APPLICATION NO.	FILING DATE	FIRST NAMED INVENTOR	ATTORNEY DOCKET NO.	CONFIRMATION NO.
10/808,816	03/25/2004	Thanakritt Fufuangvanich	77-2	6595

Office Action Summary	Application No. 10/808,816	Applicant(s) FUFUANGVANICH, THANAKRITT	
	Examiner David C. Reese	Art Unit 3677

THIS NON-FINAL ACTION IS RESPONSIVE TO THE AMENDMENT FILED 5/23/2006.

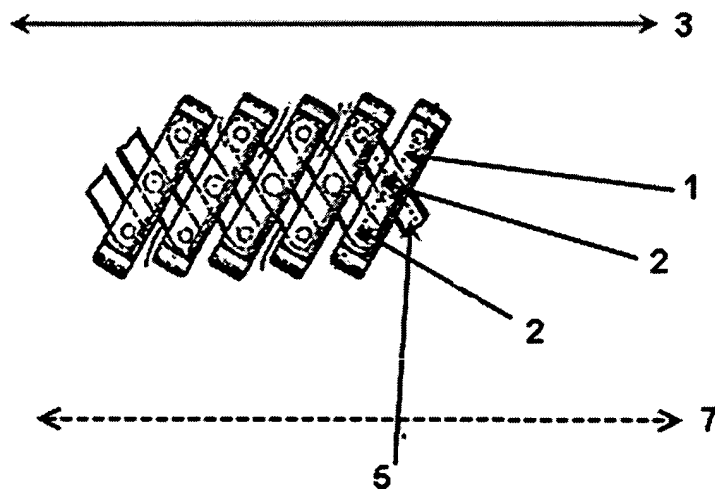
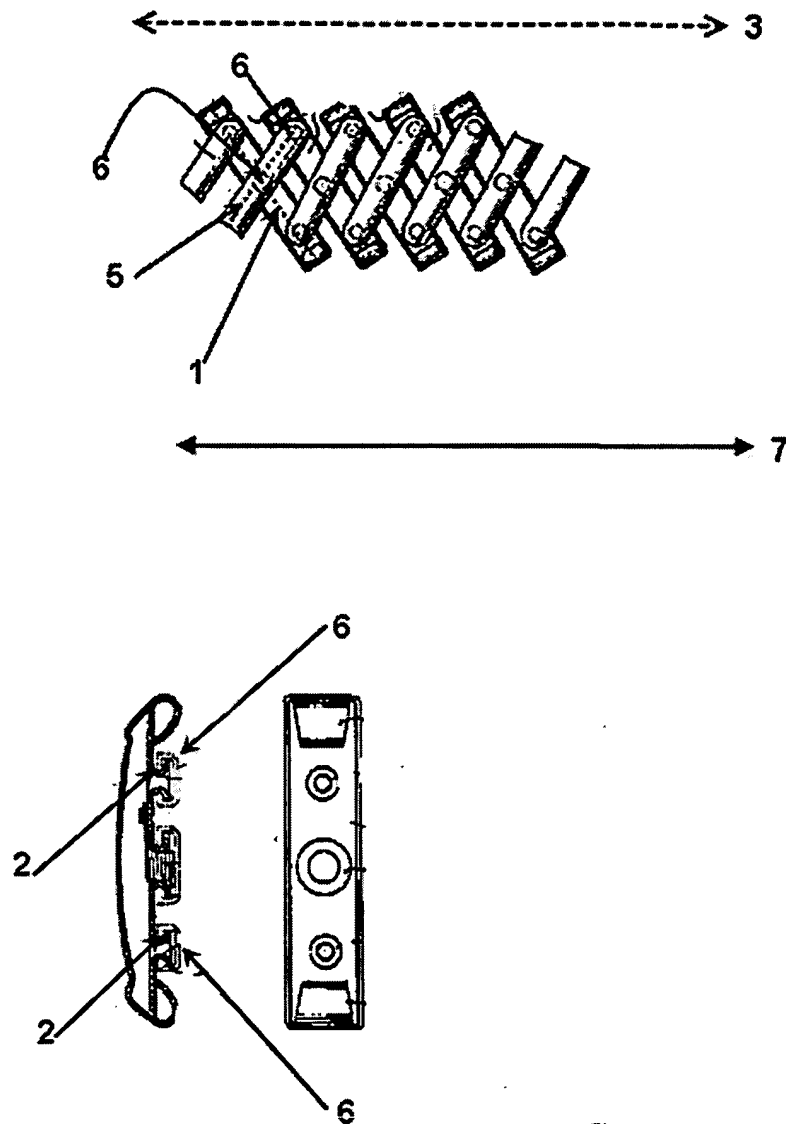
As for Claim 1, Minematsu teaches of a necklace (could be worn as a necklace), comprising (see figures below):

a first plurality of links (1), each link of the first plurality (1) having first (2) and second (2) hinge elements that mate with other links (5), and restrict articulation between the links (1) to a first plane; (3, across the page) and

a second plurality of links (5), each link of the second plurality (5) having first (6) and second (6) hinge elements that mate with other links (1) and restrict articulation between the links (5) to a second plane (7, across the page, underneath 3 in the first figure; above 3 in the second figure), where the second plane (7) is at an angle (the two planes, which are parallel to one another, are thus at an angle to one another) with respect to the first plane (3).

Re: Claim 4, further comprising means (2, 6) for connecting the first plurality of links (1) to the second plurality of links (5).

Re: Claim 5, where the means for connecting the first plurality of links (1) to a second plurality of links (5) comprises an interconnecting link (2, 6) comprising (see figures above):

a first hinge element (2) restricting articulation to a first plane (3, across the page); and

a second hinge element (6) restricting articulation to a second plane (7, across the page, underneath 3 in the first figure; above 3 in the second figure), where the second plane (7) is at an angle (the two planes, which are parallel to one another, are thus at an angle to one another) with respect to the first plane (3).

Re: Claim 6, where the first hinge element (2) of the interconnecting link (2,6) restricts articulation to the first plane (3); and the second hinge (6) of the interconnecting link (2,6) restricts articulation to the second plane (7).

As for Claim 12, Minematsu teaches of an interconnecting link (2, 6) for connecting a first plurality of link (1) to a second plurality of links (5) in a necklace, comprising (see figures above):

a first hinge element (2) restricting articulation to a first plane (3, across the page); and
a second hinge element (6) restricting articulation to a second plane (7, across the page, underneath 3 in the first figure; above 3 in the second figure), where the second plane (7) is at an angle (the two planes, which are parallel to one another, are thus at an angle to one another) with respect to the first plane (3).
